### **DESIGN NOTES**

PROJECT	Marine Parade Residence
Date	31/03/2021
Subject	Energy / Sustainability Review
JN	123462

CADDS Group have undertaken an initial review of the proposed Marine Parade Residences at 120 Marine Parade, Cottesloe. The intent of the analysis is to

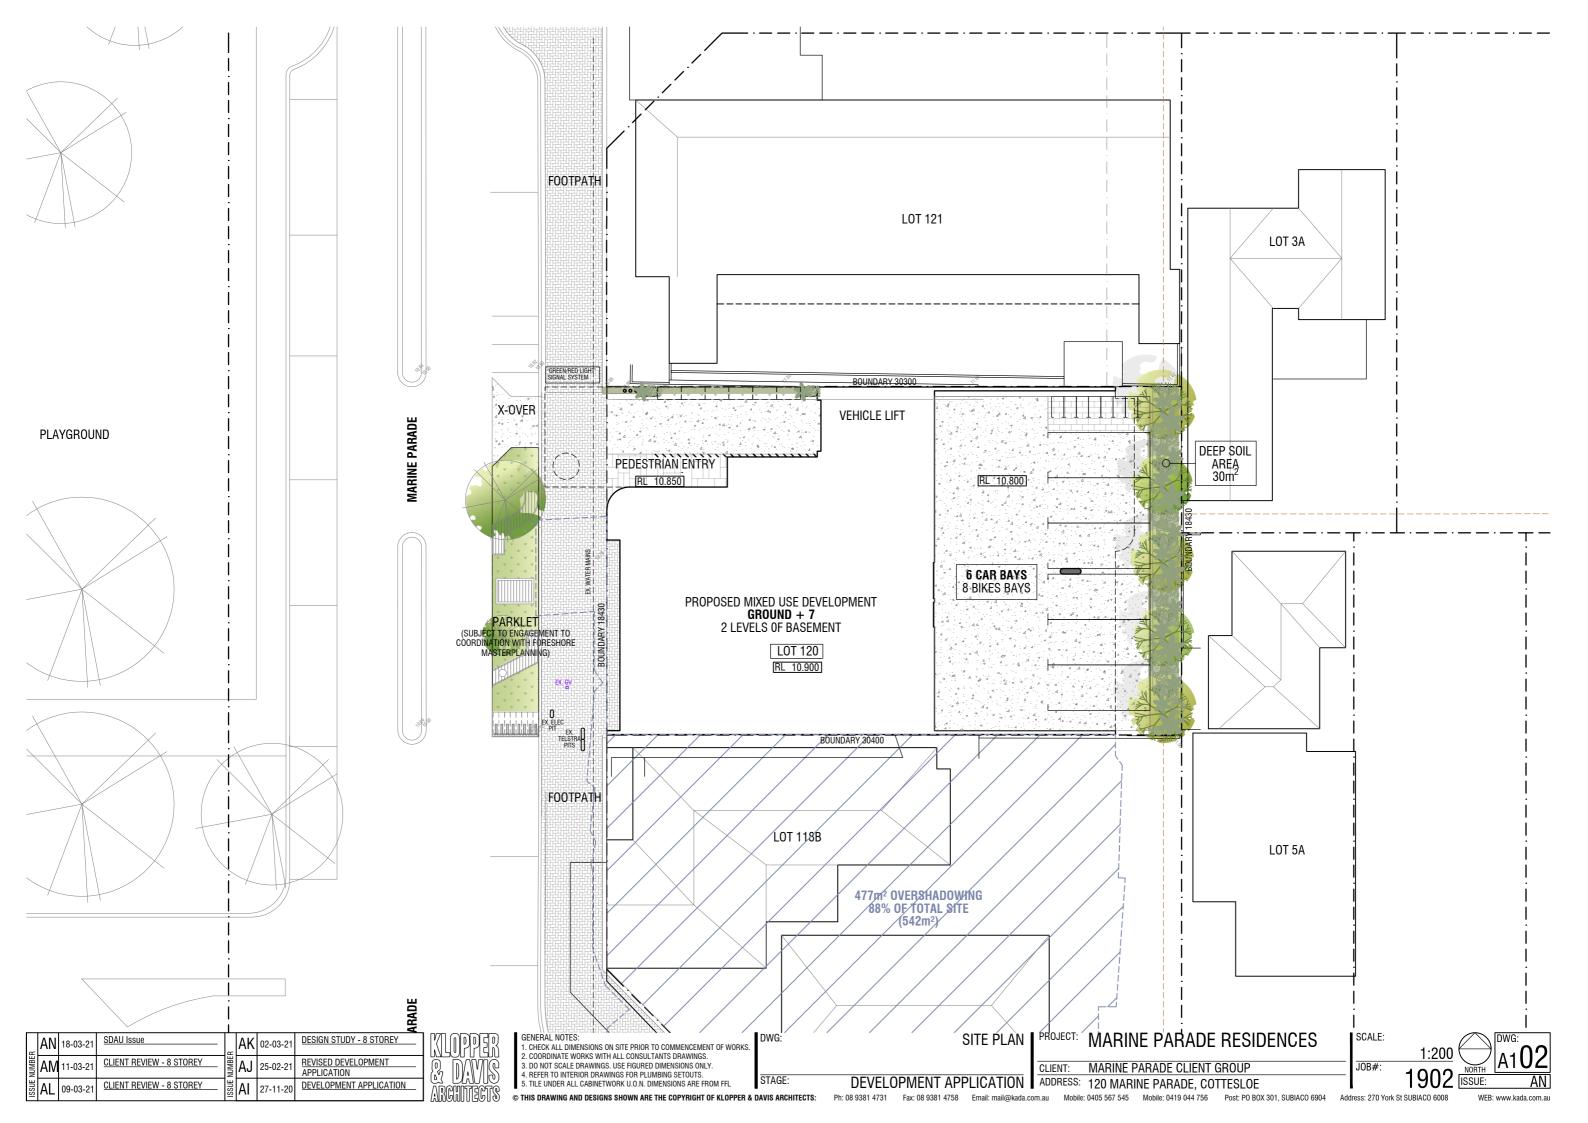
- Under Slab insulation (ie 25mm K10 Soffit insulation board or equivalent) to apartments with large areas of exposed floors to carpark. See attached plans for extent of requirement.
  - Discussion point take note of where insulation cannot be installed due to functionality or aesthetics

Floors	Exposed	Minimum R1.1 insulation
	Between apartment	None
